Docket Number:	19-SPPE-02
Project Title:	Walsh Data Center
TN #:	231293
Document Title:	WP, LLC's Responses to Report of Conversation TN 230445 - FAA Surfaces Analysis
Description:	N/A
Filer:	Scott Galati
Organization:	DayZenLLC
Submitter Role:	Applicant Representative
Submission Date:	12/19/2019 1:53:15 PM
Docketed Date:	12/19/2019

**WP, LLC'S RESPONSES TO REPORT OF CONVERSATION
TN 230445 – FAA SURFACES
WALSH BACKUP GENERATING FACILITY (19-SPPE-02)**

Figure 1: Norman Y Mineta San Jose International Airport (SJC) 77.19 imaginary surfaces (black) overlying the Walsh Data Center building project

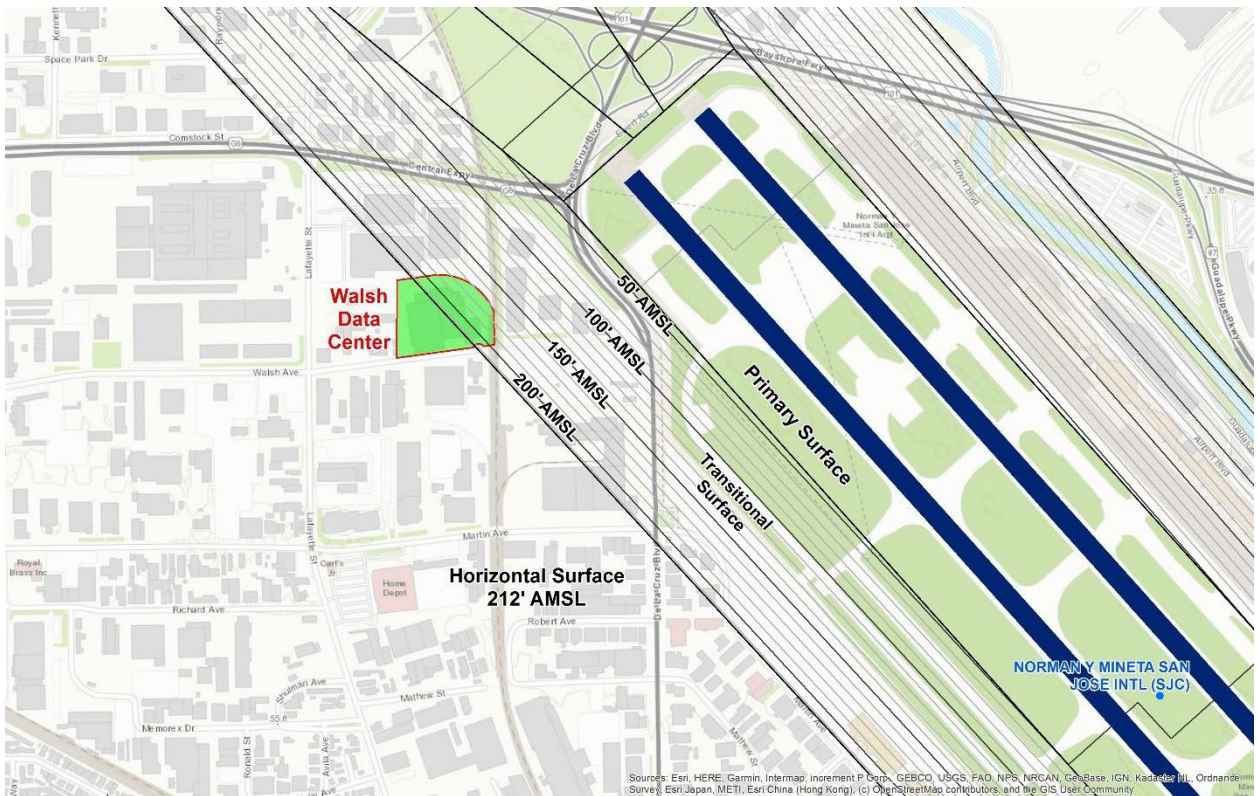
The transitional and horizontal imaginary surfaces (*Figure 1*) range from 168 to 212 feet AMSL and are the lowest imaginary surfaces overlying the study area. However, at 123 feet AGL, proposed buildings within the defined study area should not exceed these surfaces.

Figure 2: Norman Y Mineta San Jose International Airport (SJC) Runway 12R approach RPZ (purple) and Runway 30L departure RPZ (blue)

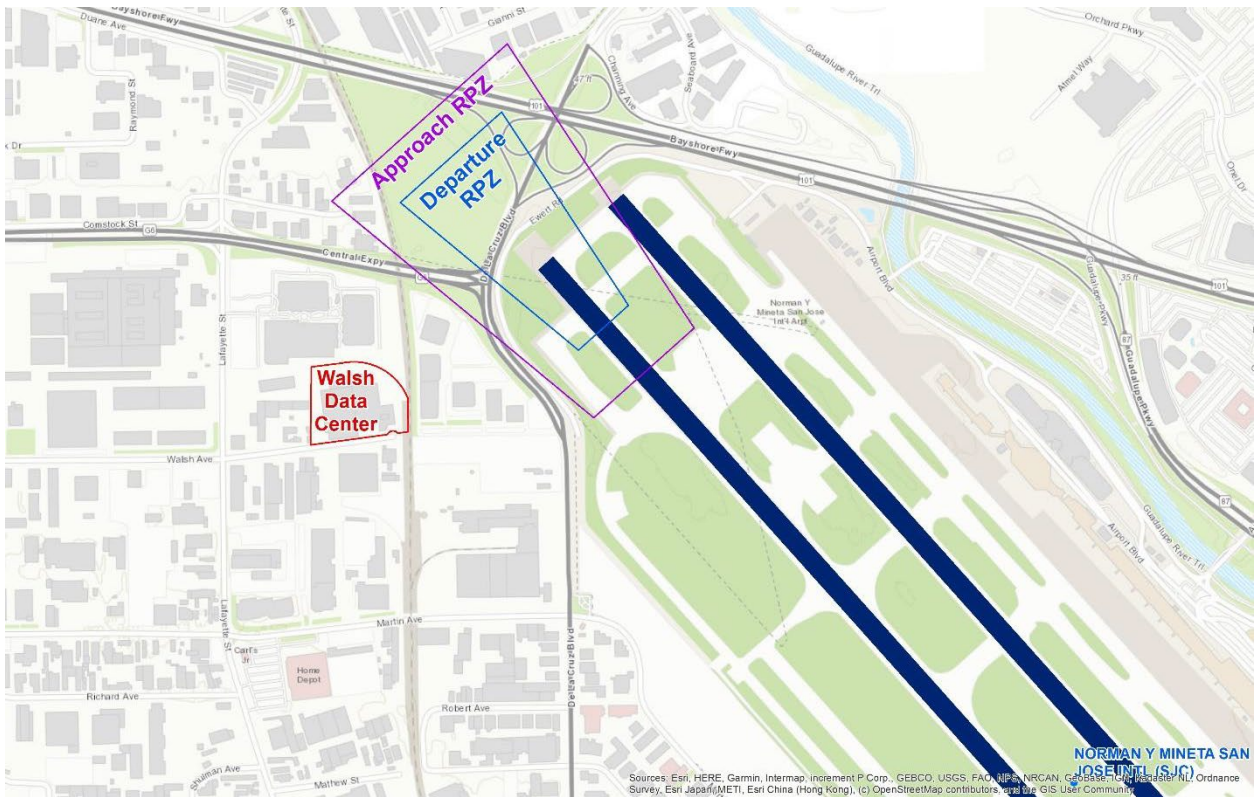
Norman Y Mineta San Jose International Airport RPZs (e.g., *Figure 2*) do not overlie the Walsh Data Center building project study area. Therefore, RPZs should not limit development within the defined study area.

Figure 3: VFR traffic pattern airspace overlying the Walsh Data Center building project

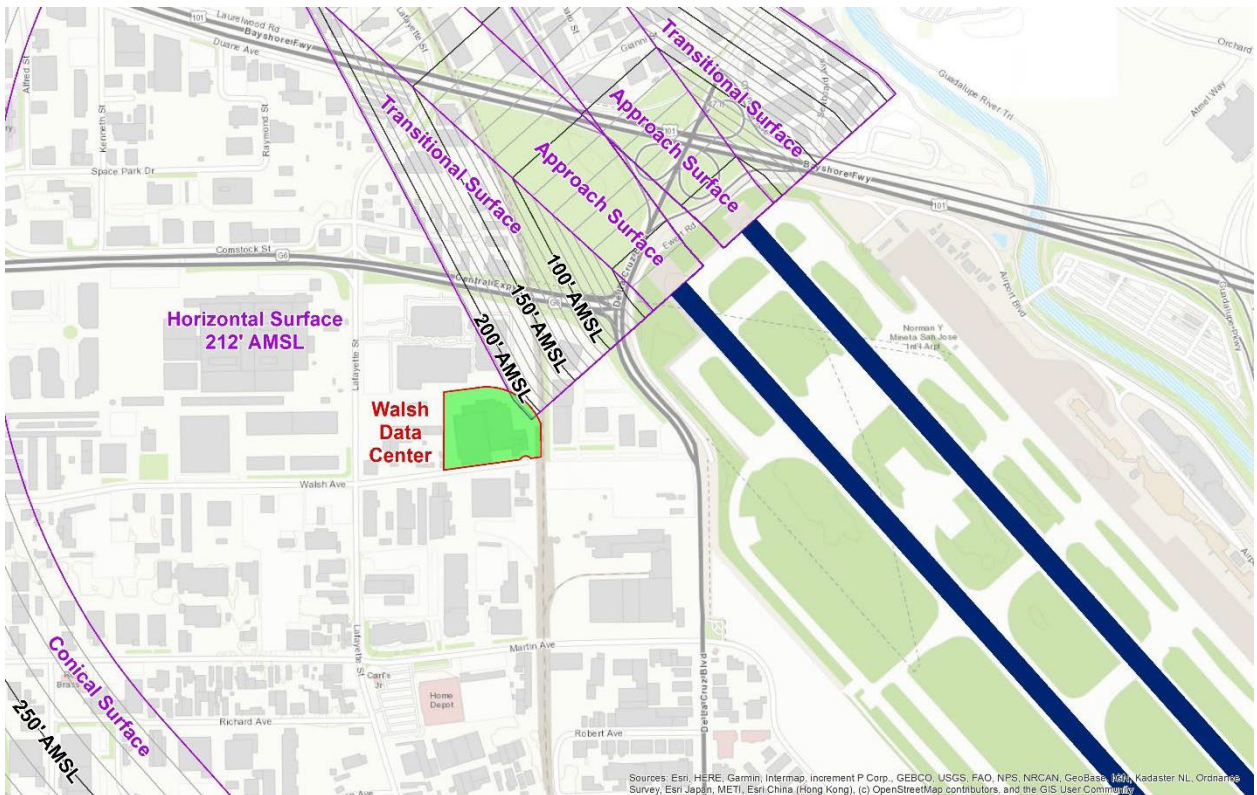
VFR traffic pattern airspace (e.g., *Figure 3*) is in excess of other lower surfaces and should not limit 123-foot AGL buildings within the defined study area.

Figure 4: Precision Approach Path Indicators (PAPI) in proximity to the Walsh Data Center building project

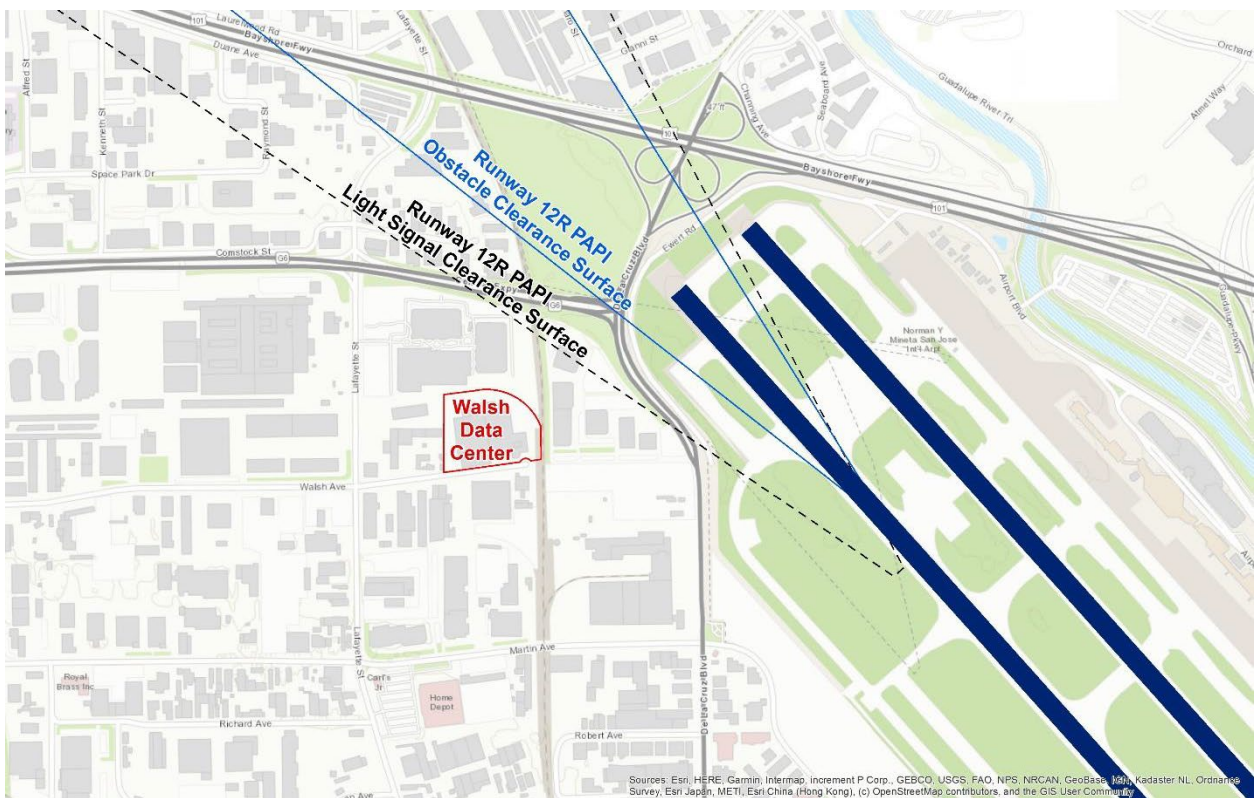
VGSI obstacle clearance surfaces and light signal clearance surfaces (e.g., *Figure 4*) do not overlie the Walsh Data Center building project and should not limit 123-foot AGL buildings within the defined study area.

Figure 5: Norman Y Mineta San Jose International Airport (SJC) Runway 12R obstacle departure procedure assessment

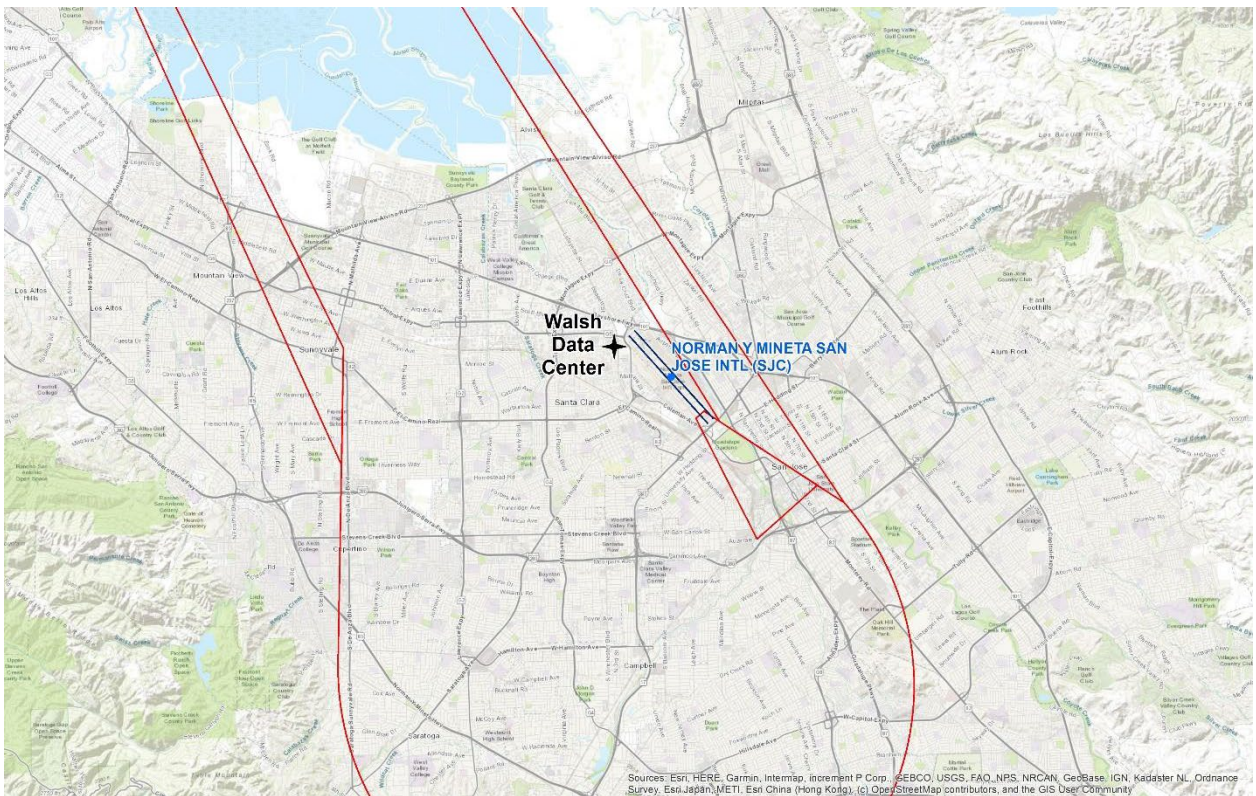
Instrument departure procedure obstacle clearance surfaces do not overlie or are in excess of other, lower surfaces (e.g., *Figure 5*) and should not limit 123-foot AGL buildings within the defined study area.

Figure 6: Norman Y Mineta San Jose International Airport (SJC) RNAV (GPS) Approach to Runway 12L with LNAV/VNAV final and missed approach segment obstacle evaluation areas (red)

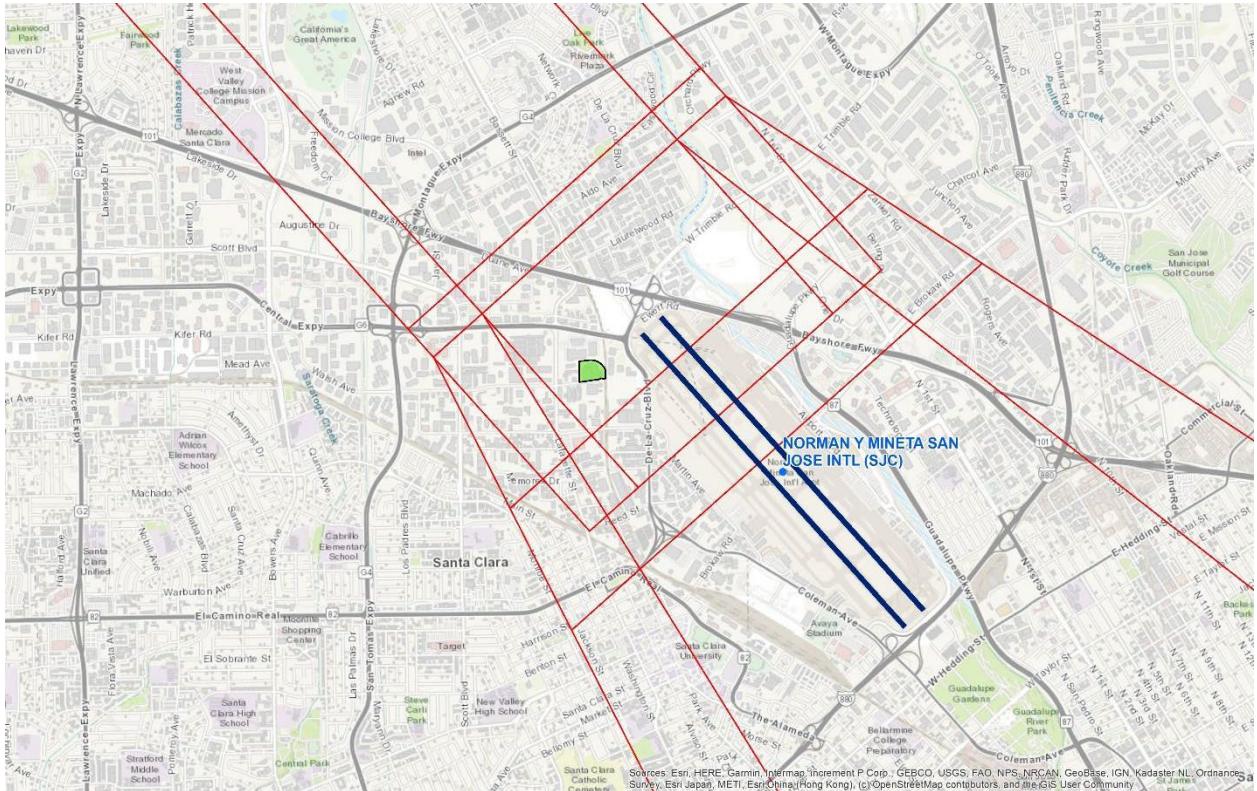
The LNAV/VNAV final segment and missed approach segment primary area obstacle clearance surfaces (red outline, *Figure 6*) are 180 feet AMSL and are the lowest height constraints overlying the entire study area. However, USGS elevation data indicates that these surfaces should not limit 123-foot AGL buildings within the defined study area.

Figure 8: Northern California (NCT) TRACON FUSION 3 MVA sectors (black)

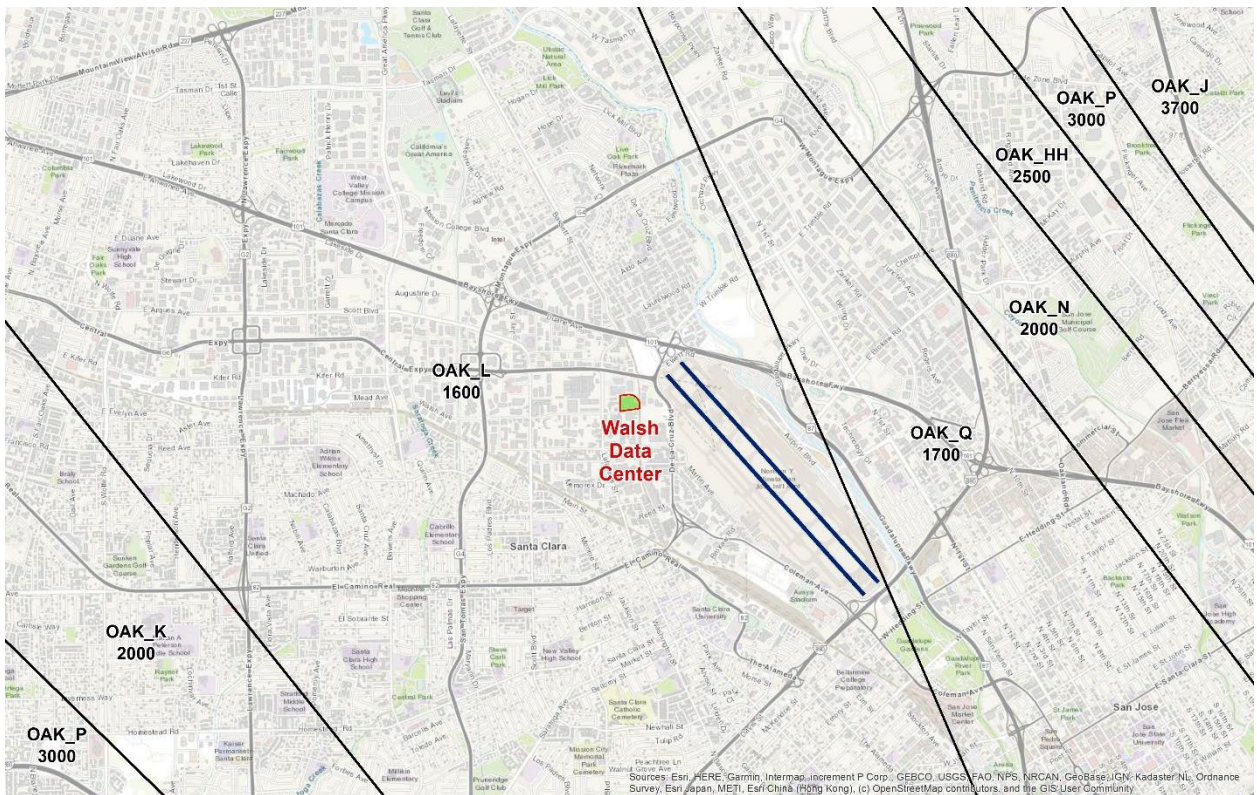
MVA and MIA obstacle clearance surfaces (e.g., *Figure 8*) are in excess of other, lower surfaces and should not limit 123-foot AGL buildings within the defined study area.
